TXDOT AVIATION STATEWIDE AIRPORT ELECTRICAL CONSTRUCTION PROJECT (AVSAE) - GROUP ALPHA
TxDOT CSJ No. 4222AVSAEA

ADDENDUM NO. 3

May 14, 2025

1 E2.2 NEW SIGN AND BASE DETAIL
SCALE: N.T.S.

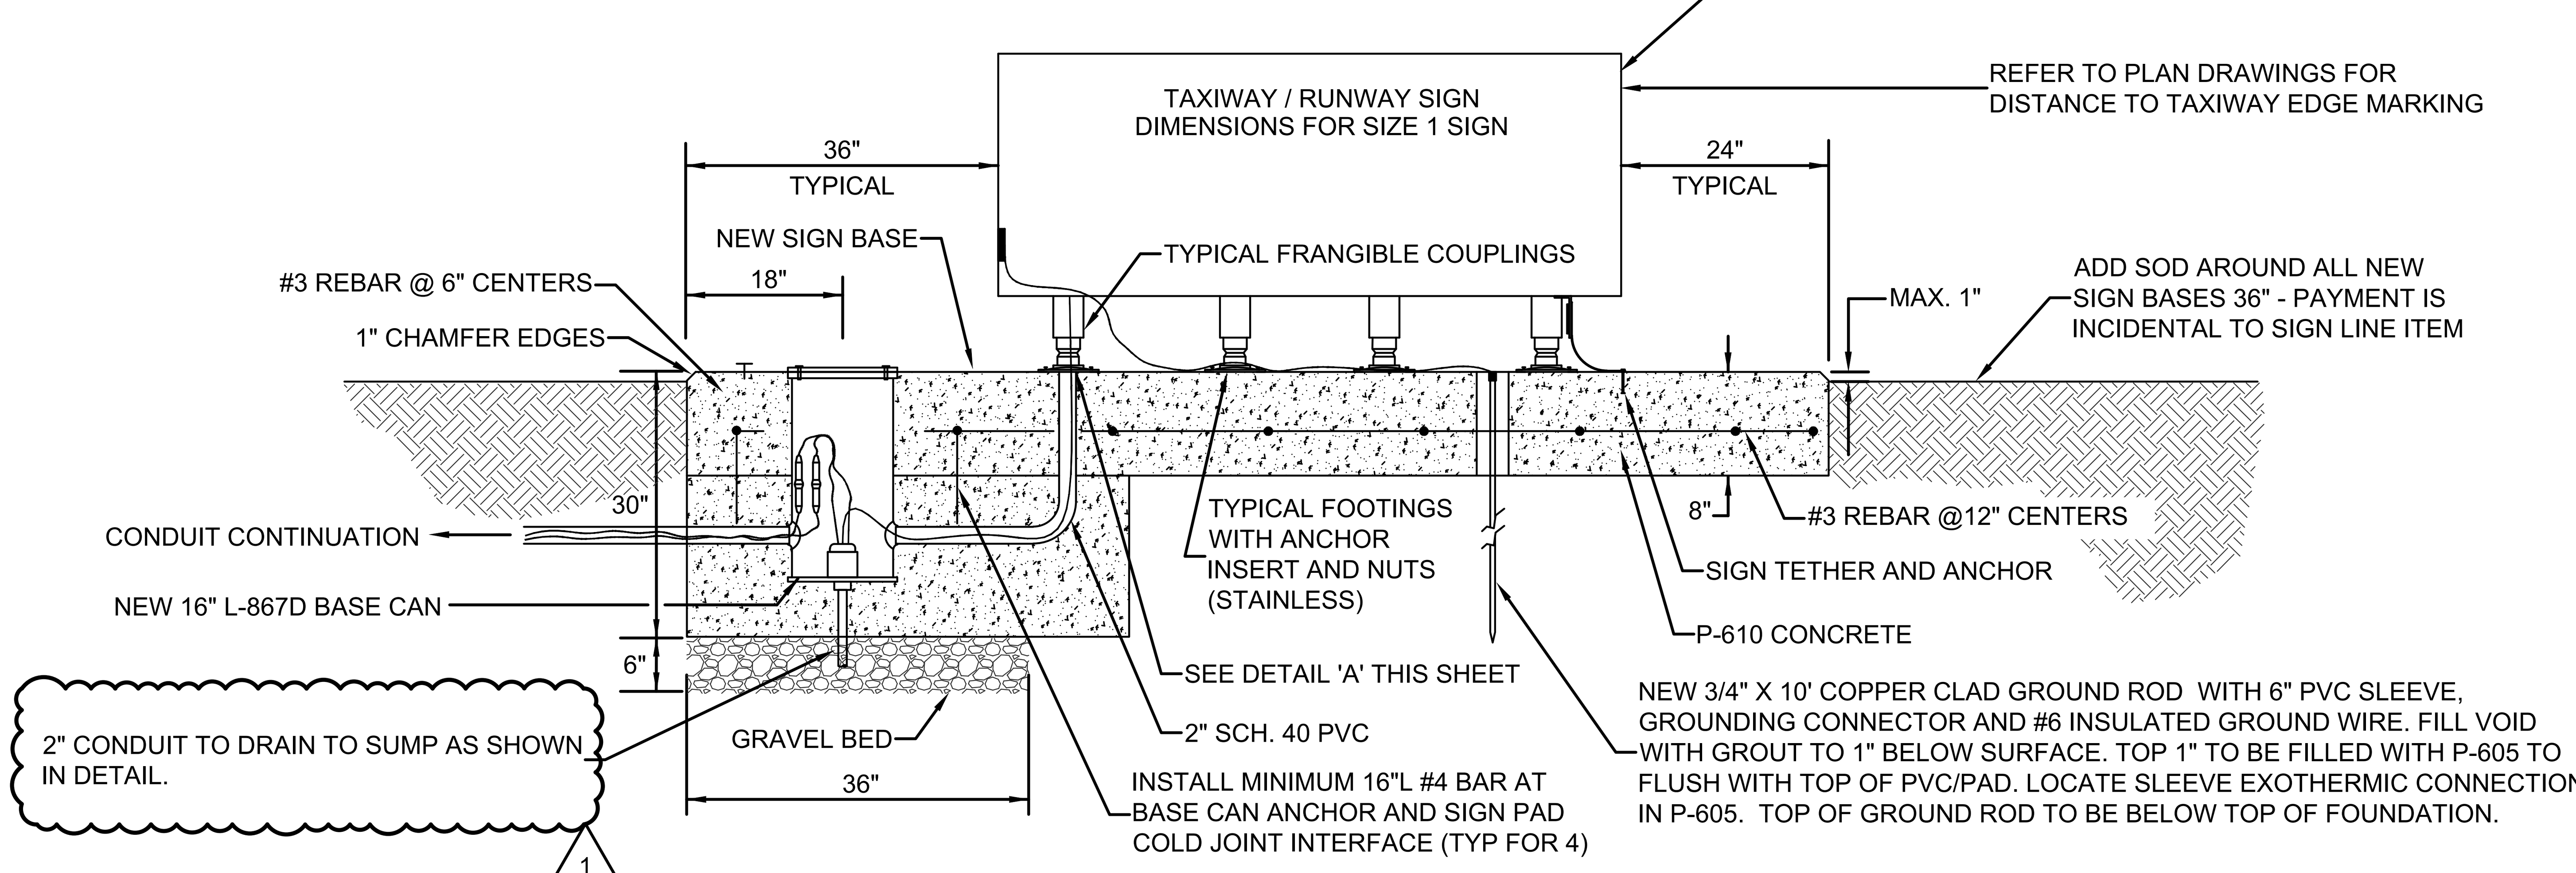
e) **Sheet E2.2 – General Airfield Electrical Details. Revised detail 1 to clarify ground rod material and drain line conduit.**
f) **Sheet E2.3 – General Airfield Electrical Details. Revised detail 5 to update duct bank size. Revised detail 6 to remove unnecessary callout.**

50. E2.2 Sign Details show both cu clad ground rods and stainless-steel ground rods. Can bidders standardize on cu clad ground rods for the entire project?
RESPONSE: An updated detail has been included as part of Addendum 3.

3 E2.4 10-WAY JUNCTION CAN PLAZA
SCALE: N.T.S.

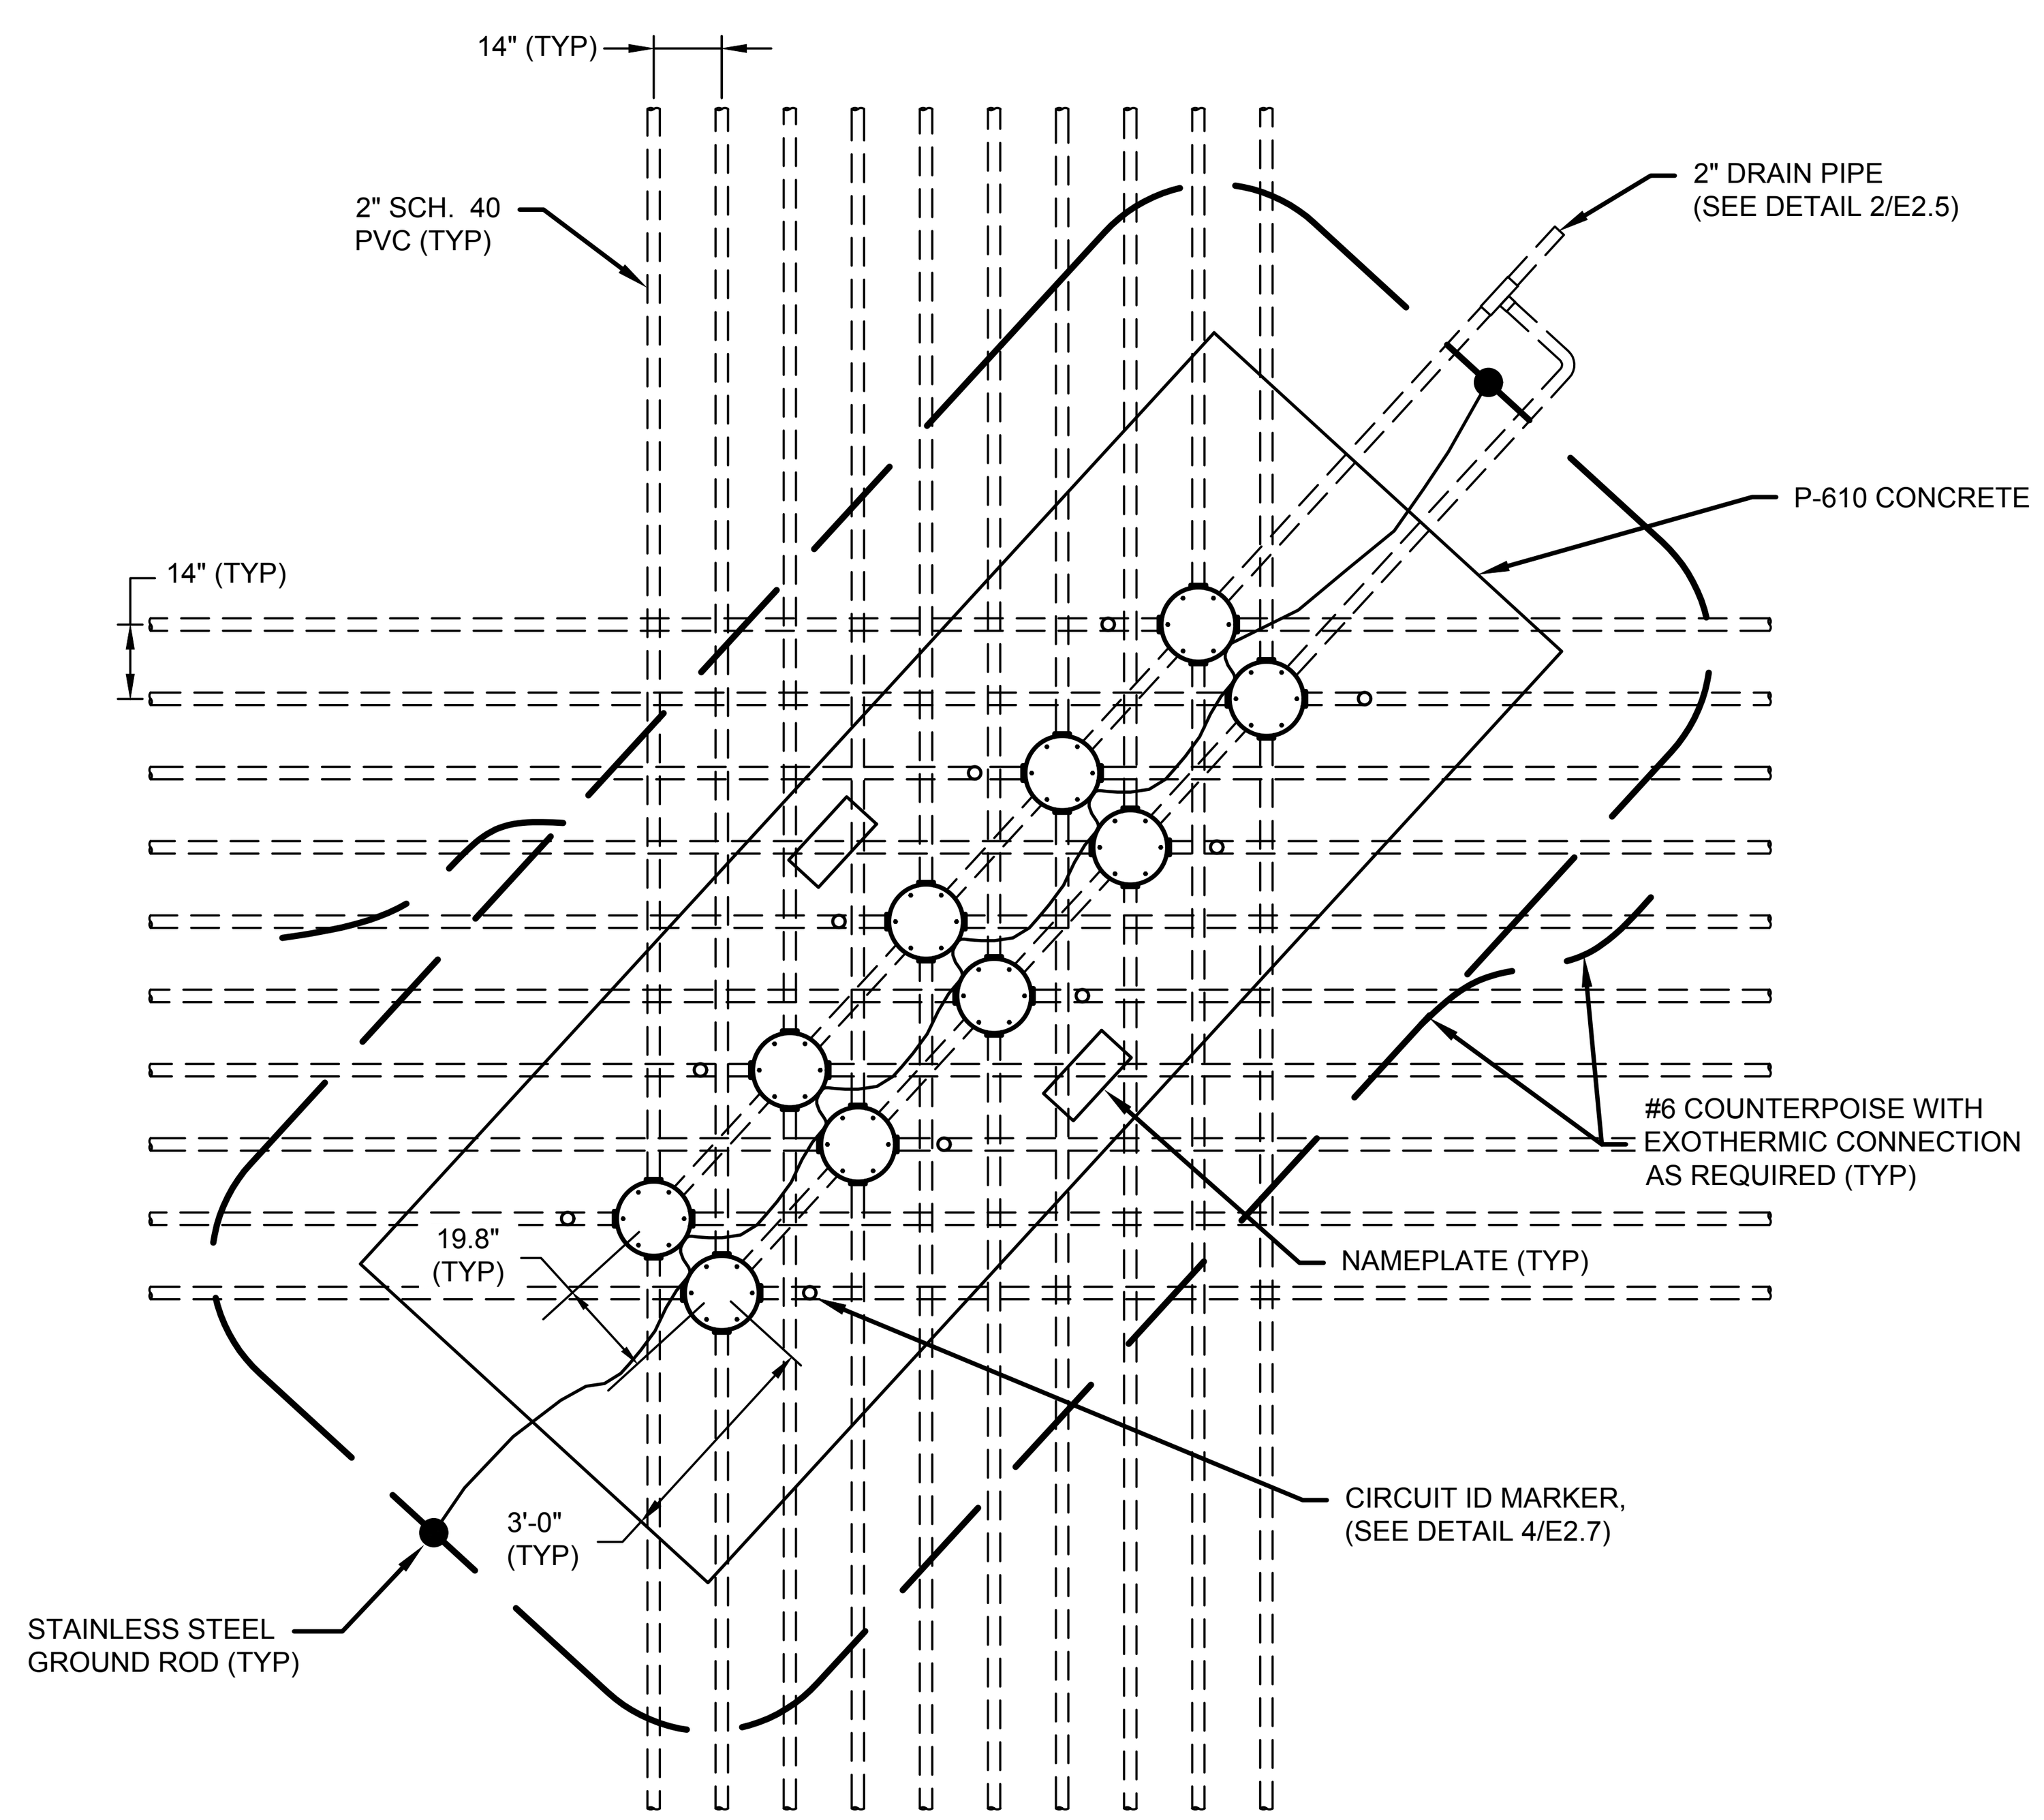
g) **Sheet E2.4 – General Airfield Electrical Details. Revised detail 3 to update JCP size.**
h) **Sheet E2.5 – General Airfield Electrical Details. Revised detail 1 to clarify directional drilling operation.**

1 / EG4.1 **VAULT SITE PLAN**

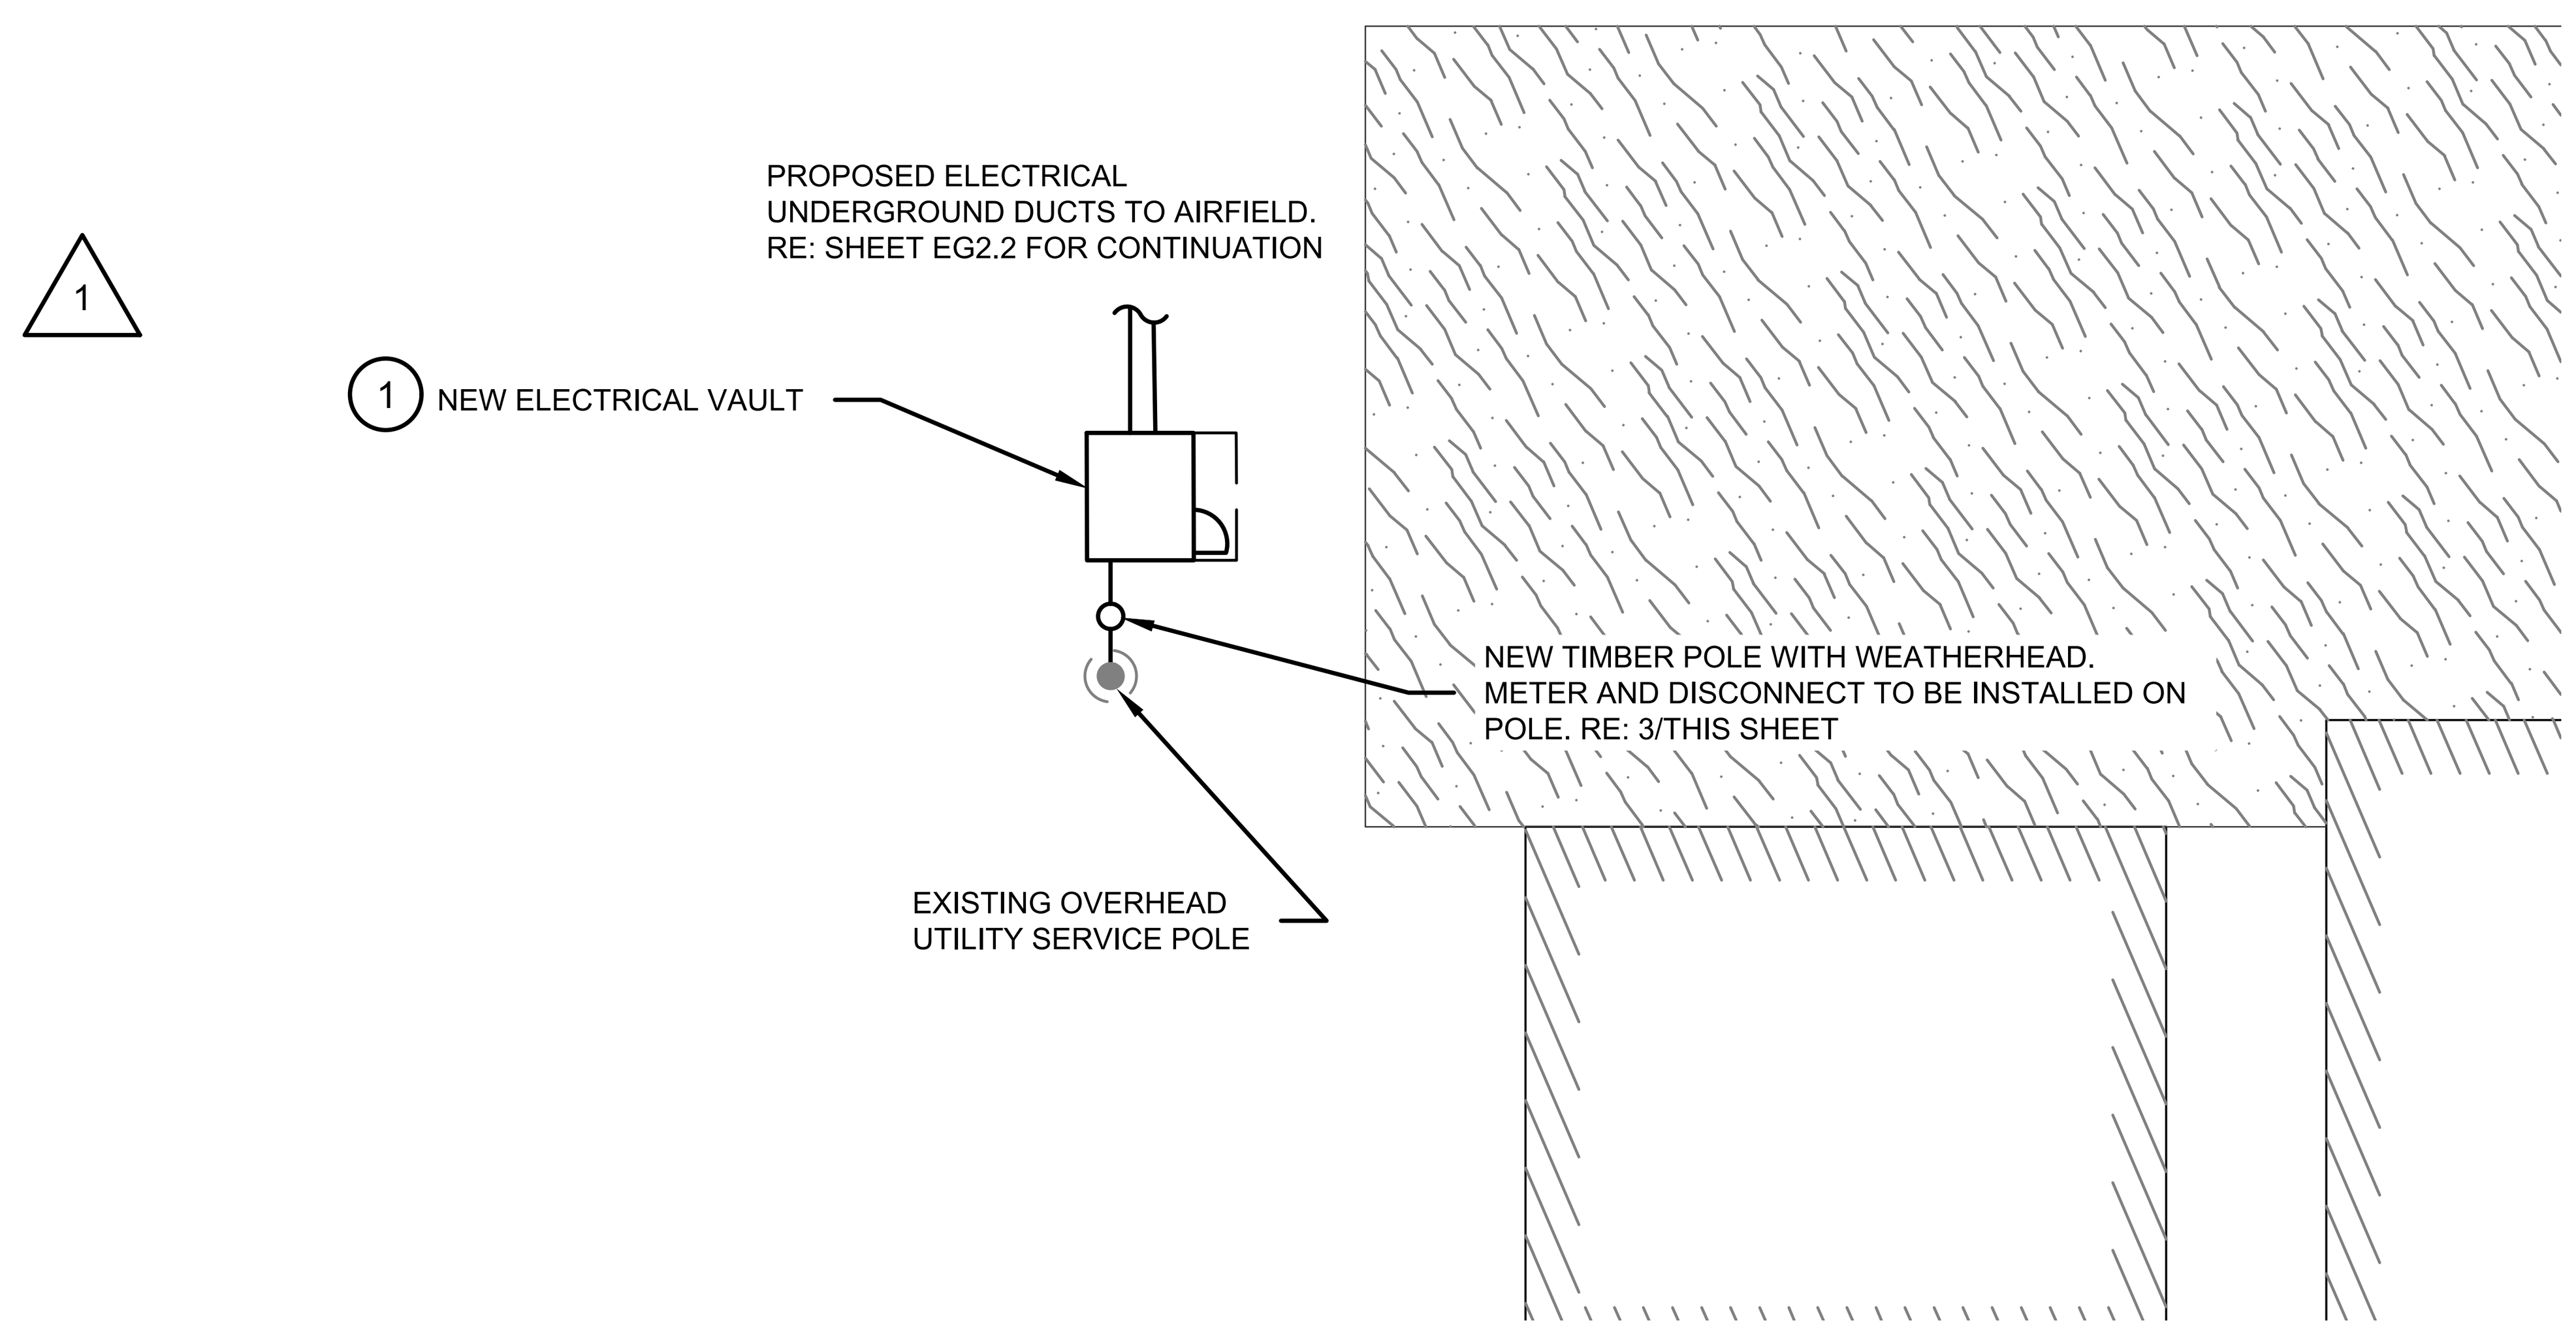
t) **Sheet EG4.1 –Electrical Vault Plan. Revised details to clarify vault foundation plan, show doorstep, and update keyed note 1 for HVAC verbiage.**
u) **Sheet EG4.2 –Electrical Vault Plan. Revised details to update the proposed vault plan, wall elevations, and update panel schedule.**
